120 Carrs Drive Yamba

Traffic Impact Assessment

INFORMATION REQUEST RESPONSE

This response has been prepared in response to the Information Request (IR) issues by Clarence Valley Council (Council) in relation to the proposed manufactured home estate development located at 120 Carrs Drive, Yamba.

**Figure 3.1: Seasonal Traffic Volumes**

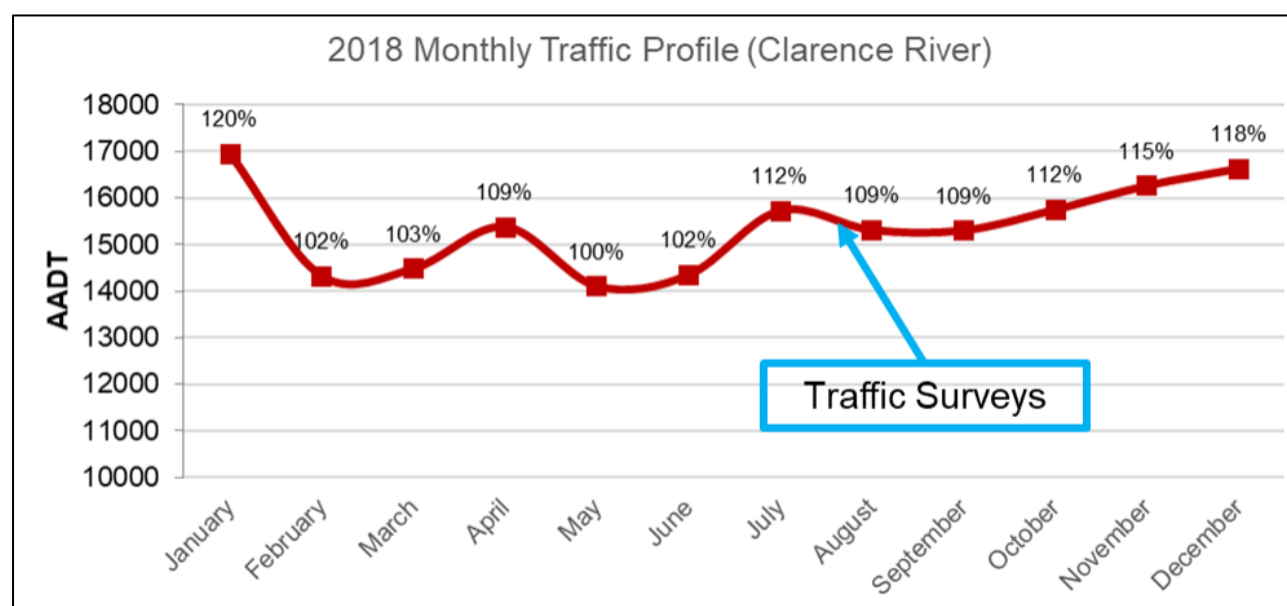
Seasonal traffic impacts shall be assessed for peak holiday periods.

The traffic assessment has been revised to include sensitivity test SIDRA's with an 11% seasonality factor applied. As shown in Section 3 of the revised report below, peak hour development traffic is not expected to result in adverse impacts to the surrounding road network during the peak summer season.

Traffic surveys were undertaken in July after the school holiday period. As such, and based on the above, seasonal peak traffic volumes in January are expected to be approximately 11% higher than surveyed. An 11% increase was therefore applied to forecast background volumes to determine expected seasonal peak volumes. Background and design volumes, with the seasonality factor applied, are provided at **Appendix C** (Sheet 9 – Sheet 12) for the expected year of opening (2024) and 10-year design horizon (2034).
